**Dendrobium – Area 3A – Longwall 19A – Subsidence Management Plan  
Addendum to Report No. MSEC1234 (Rev. B)**

## Addendum to Groundwater Assessment of Longwall 19A re: revised longwall geometry

<b>To:</b>	Cody Brady (Illawarra Metallurgical Coal)	cc:
<b>From:</b>	Stuart Brown	
<b>Subject:</b>	<b>Assessment of surface water flow and shallow groundwater effects of proposed Dendrobium Longwall 19A: Revised longwall geometry</b>	
<b>Date:</b>	20 February 2023	<b>Ref:</b> D23208

Figure 4-6 Modelled groundwater levels near Swamp 15a – revised layout

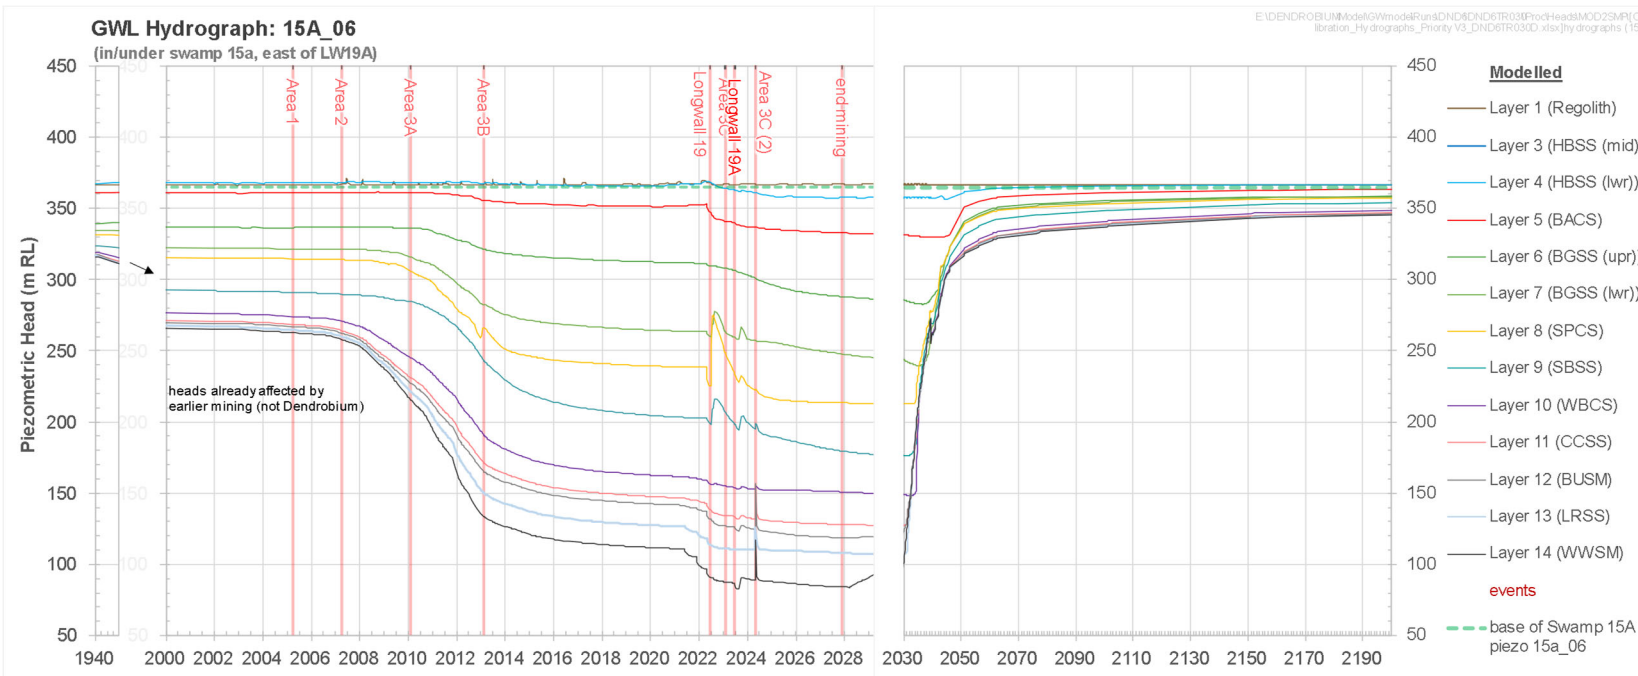
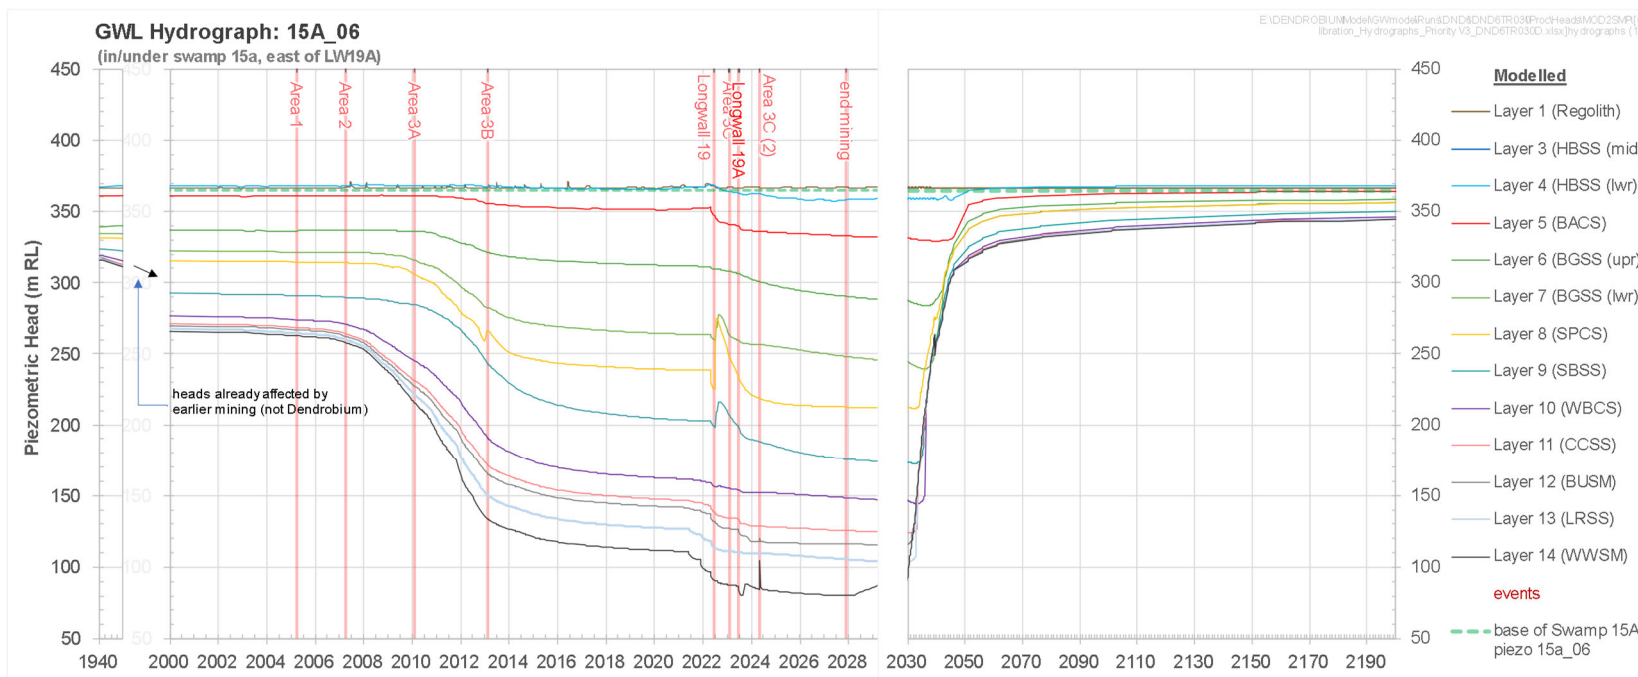
When comparing these modelled groundwater level hydrographs for this site adjacent to Wongawilli Creek (**Figure 4-5** and **Figure 4-6**, there is a slight increase in the drawdown simulated in the deeper units; Bulgo Sandstone (BGSS) down to the Wongawilli Seam (WWSM). This is because of the increased panel length at its eastern end and despite the change in void width. Note however that the change in drawdown is not significant, given that drawdown is still 75-200 m and still resulting in some horizons of zero or near-zero groundwater pressure.

In the shallower strata, the main difference, and even this is very minor, is in the lower Hawkesbury Sandstone (HBSS lwr). The assessment of the previous layout (**Figure 4-5**) indicated drawdown from 368 mAH down to 356 mAH, i.e. 12 m drawdown to below the local base of the swamp, before recovering to 2 m above the base of the swamp (366 mAH).

For the revised layout (**Figure 4-6**), HBSS-lwr groundwater levels are predicted to decline to 358 mAH (i.e. 10 m drawdown), before recovering to the pre-mining levels (368 mAH), also above the base of the swamp.

Figure 4-7 Modelled total groundwater inflow to Area 3A

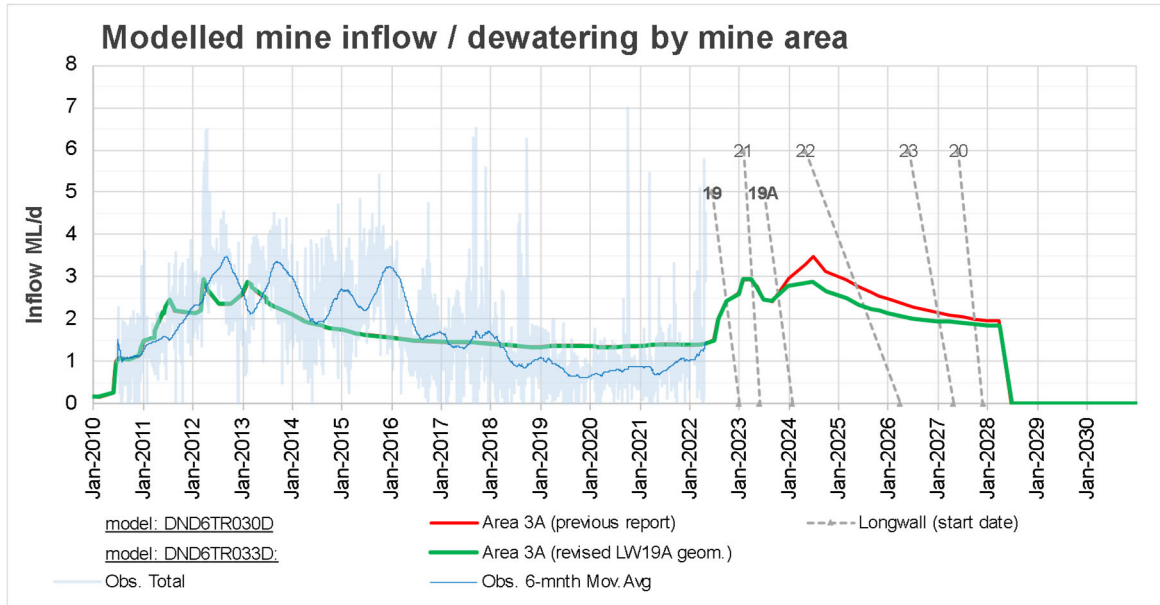
The modelled revised geometry results in a slightly lower inflow to Area 3A than was previously reported (Figure 4-7). Peak inflow following extraction of Longwall 19A is simulated as being 2.9 ML/d, compared to 3.5 ML/d in the previously modelled layout. This is obviously despite the slightly longer panel, and mainly related to the reduced void width.

Figure 4-8 Modelled total groundwater inflow to Areas 1-3C

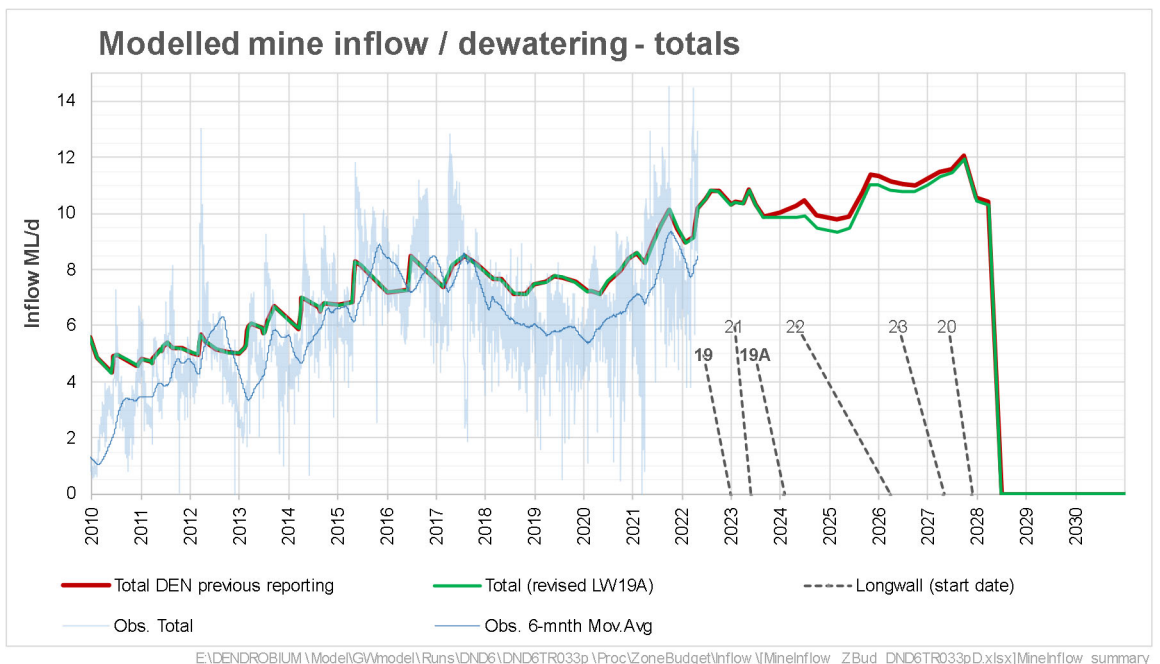
This shows a similar result to that for Area 3A, with the revised scenario simulating a peak reduction of 0.6 ML/d at the end of Longwall 19A, and an average reduction of 0.3 ML/d from the start of Longwall 19A to the simulated end of mining (2028).

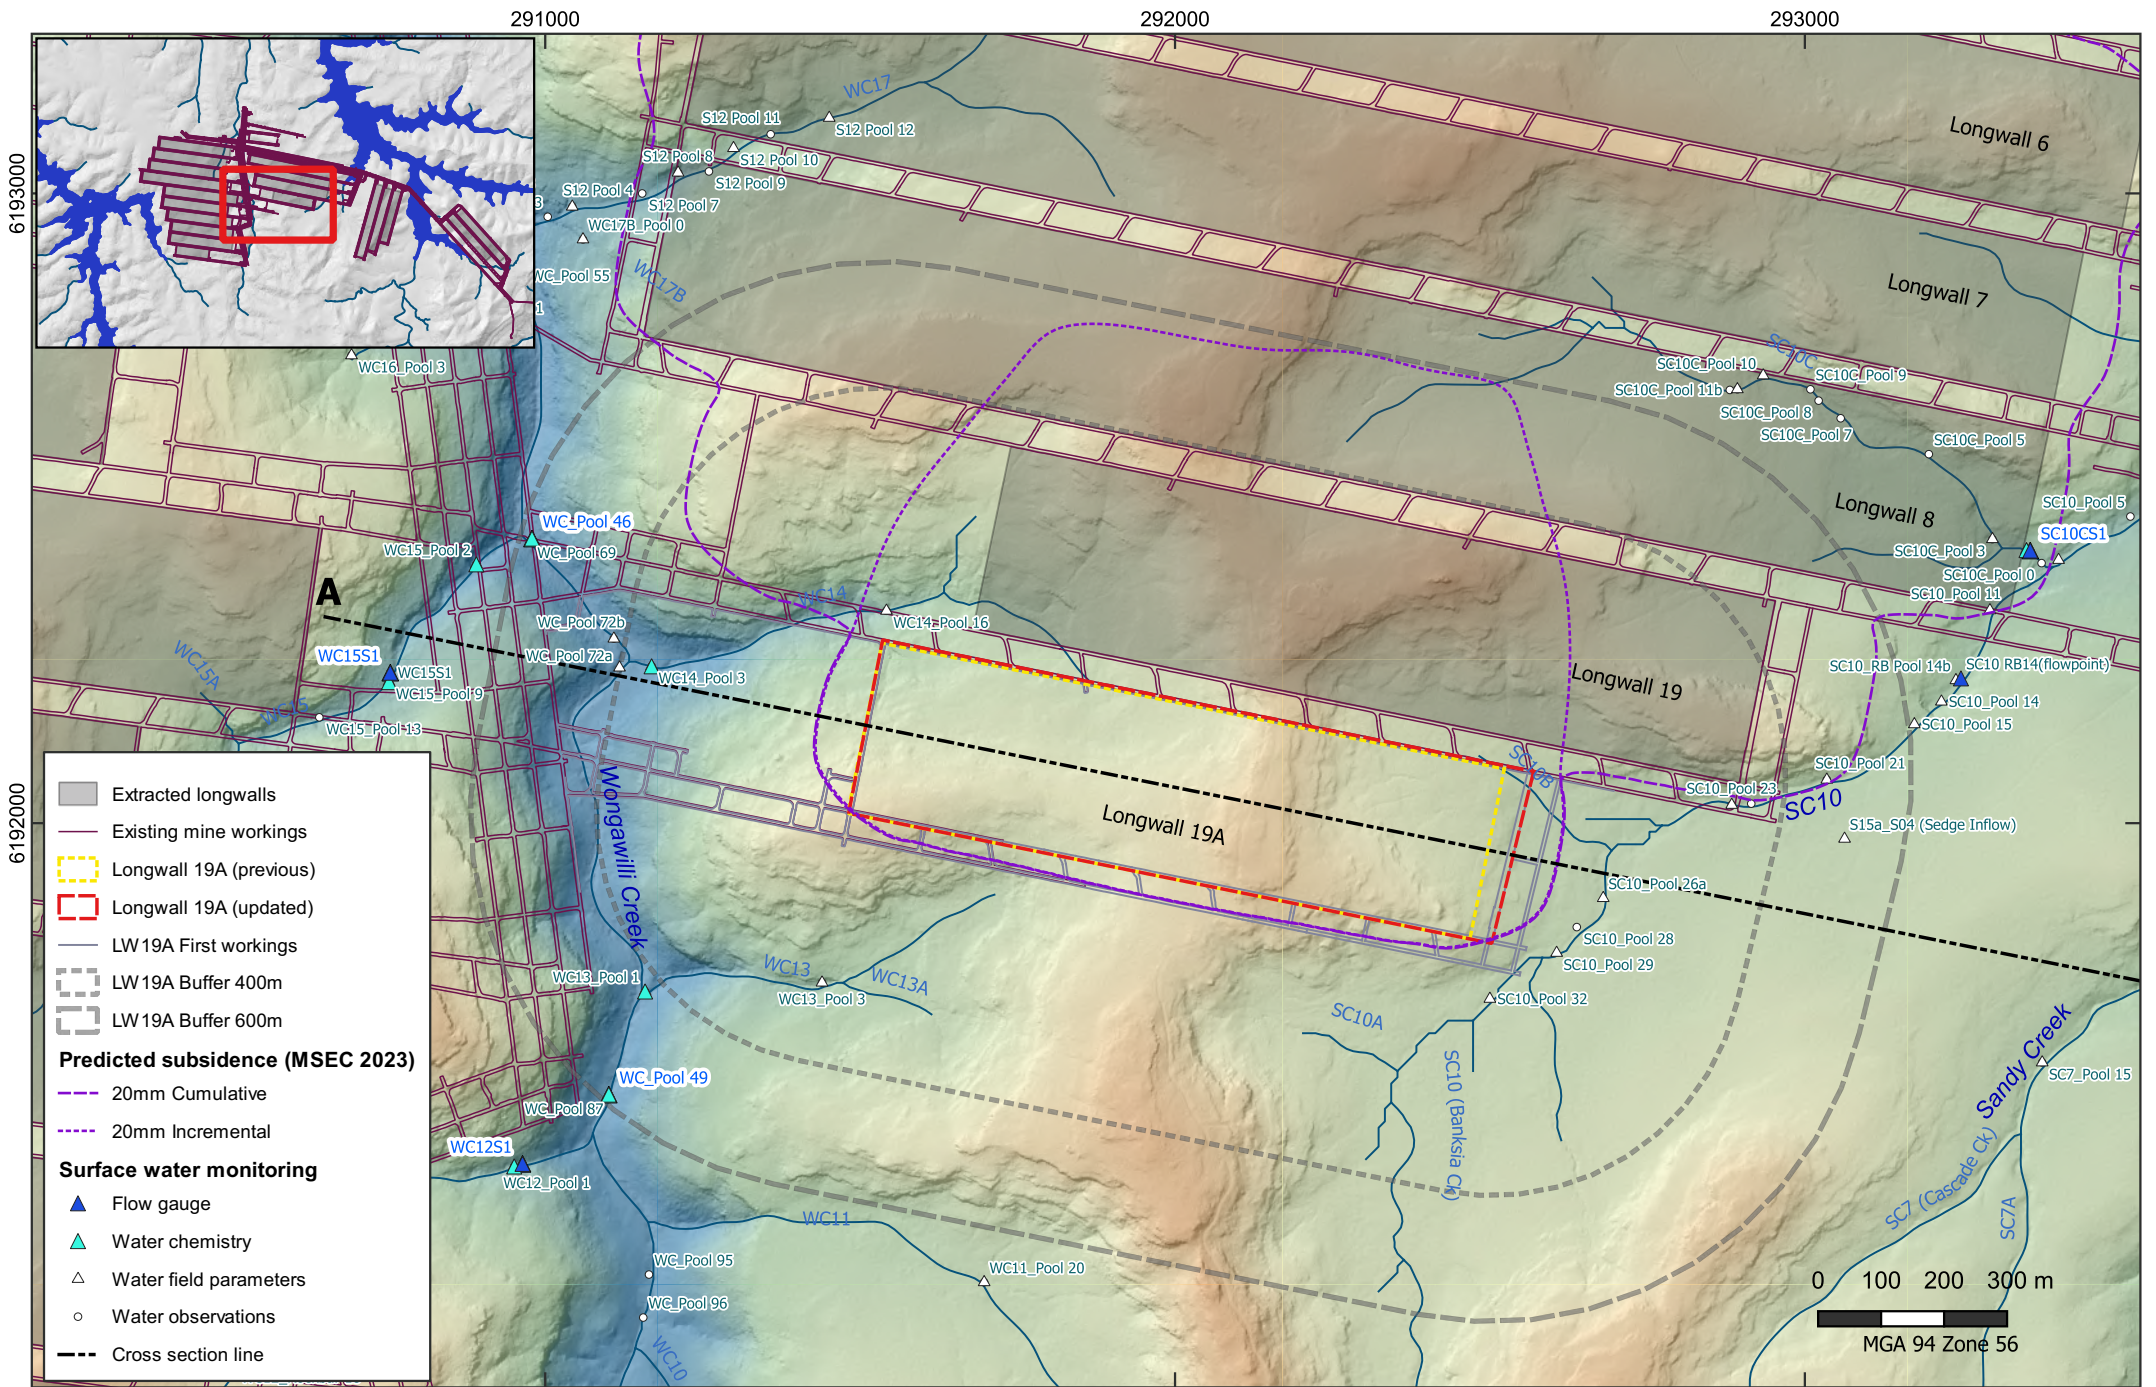
The revised and previous mining geometries for Longwall 19A are summarised in Table 1. A comparison of previous and revised longwall outlines is shown in Figure 1.

The revised longwall panel extends 42 m further at its eastern end and is 6 m wider than the previously assessed Longwall 19A. The revised longwall panel has an area 1.3 Ha or 4.7% larger than the previously assessed panel.
